YEAR  
1991

MODEL  
LEGEND  
COUPE

BULLETIN NO.  
91-039

## Popping Noise from the Front Window Regulator

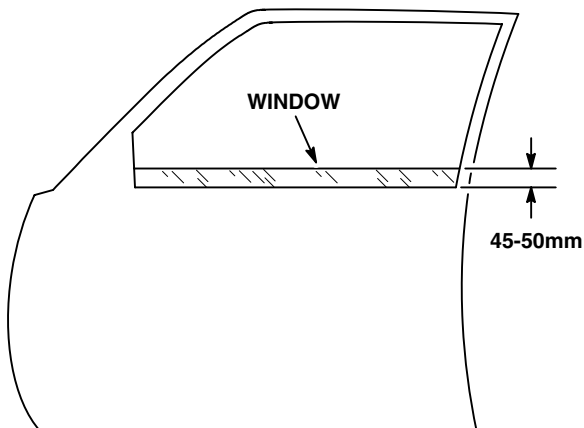
A popping noise coming from the front door when the window is raised.

A plastic washer on the window regulator obstructs the regulator movement. When the regulator overcomes the washer's resistance it makes a popping noise.

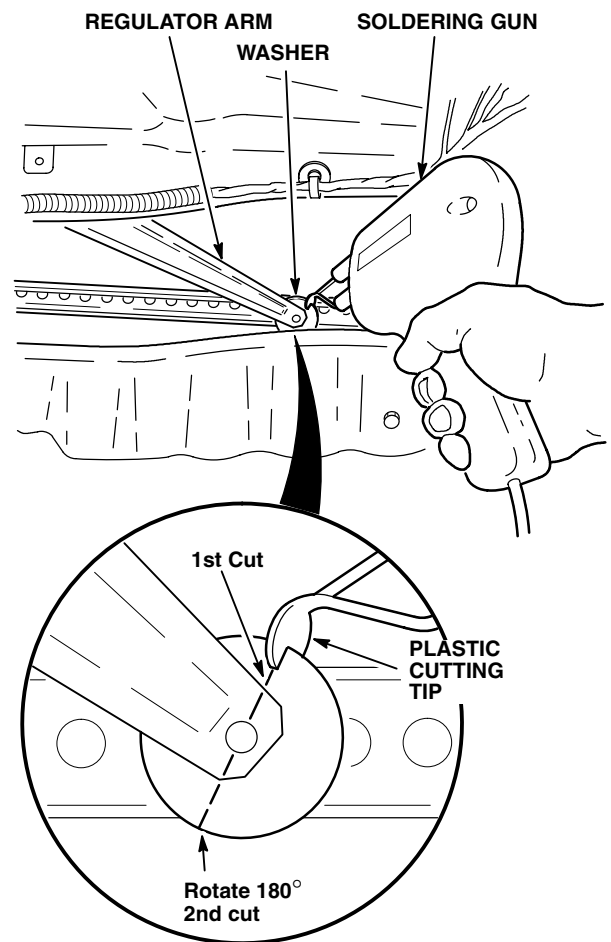
3. Using a soldering gun with a plastic cutting tip, make a cut through the washer on the regulator arm as shown.

Use care when cutting the washer to not damage the slider with the plastic cutting tip.

4. Rotate the washer 180° and make another cut through the washer with the plastic cutting tip. Remove the washer from the regulator.
5. Lubricate the sliding surfaces of the window regulator with grease.
6. Reconnect the door panel switches and check the power window, door lock and security system for operation. Once all operations are checked, reinstall the door panel.
